VIRGINIA ELECTRIC AND POWER COMPANY
NORTH ANNA POWER STATION UNIT 1
ASME SECTION XI RELIEF REQUESTS NDE-9 AND NDE-15

Request for Additional information

ASME Section XI Relief Request NDE-9

Additional Information for Relief Request NDE-9, Revision 1

Figure 1
Flaw location

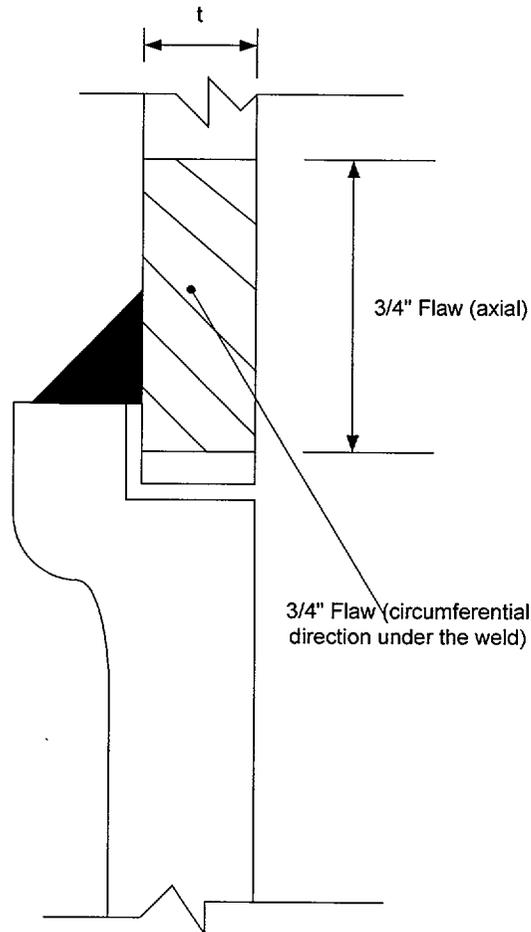
Provide the results of the failure analysis for the flaws associated with MIC in the SW System and a characterization of the flaw

There have been approximately 102 suspected MIC locations repaired in service water piping since 1996. Forty-five of the locations have been associated with socket welded piping and the balance with butt welded piping. Twenty-six suspected MIC locations have been examined by the failure analysis laboratory. Of these, nine were associated with socket welded piping and 17 with butt welded piping. For five of the socket weld locations, the lab was unable to identify an actual leak location or any evidence of MIC. For the other four, MIC pits with maximum extents ranging from about 0.06 to 0.251 inches were found. In the case of the 17 butt welds, pits with extents ranging from about 0.125 to about 0.562 inches were found. Refer to the Table, "Service Water MIC Pit Sizing," on the next page for details. In addition, although we have not documented in a formal inspection, discussions with inspection personnel indicate that where active leakage was identified, the leak appeared to be in base metal at or near the toe of the weld as opposed to actually penetrating the weld metal itself. Based on the results of failure analysis, MIC attack that results in leakage appears to grow in subsurface extent to no more than about 2.5 times the wall thickness of the affected pipe. Therefore, based on a maximum expected pipe wall thickness of about 0.173 inches (manufacturer's minimum plus 12.5%) for a 2 inch Standard schedule pipe (used in the service water system), it was determined that a 3/4 inch assumed flaw in socket welded pipe would bound any expected degraded condition (Figure 1).

Figure 2
Circumferential Flaw

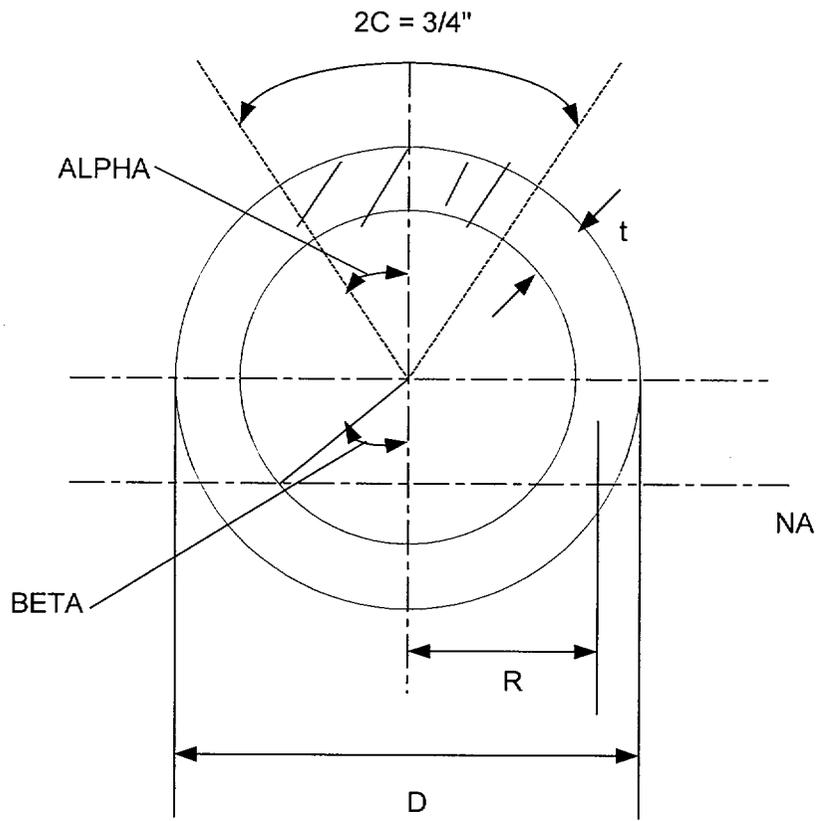
Structural analysis methodology for MIC flaw in vicinity of socket weld.

Based on the anticipated enveloping flaw on the small-bore ($\frac{3}{4}$ " - 2") piping in the vicinity of a fillet weld, the flaw will be modeled for analysis as follows:

- i) A $\frac{3}{4}$ " long through-wall circumferential flaw (Fig 2).
- ii) A $\frac{3}{4}$ " long through-wall axial flaw (Fig 3).
- iii) A $\frac{3}{4}$ " diameter hole.

The analysis will be performed using the guidance from the ASME Code Case N-513 and ANSI B31.1 Power Piping Code paragraph 104.3. The analysis will treat the flawed location as equivalent to the nominal pipe of the same size containing the enveloping flaw. The required margins in the Code Case will be demonstrated using the loadings due to pressure, deadweight, thermal expansion, seismic OBE and DBE conditions as appropriate. A residual stress equal to the yield stress in the material will be used in the analysis to address the influence of the weld. The $\frac{3}{4}$ " hole will be evaluated using the area replacement method of the ANSI B31.1 Code.
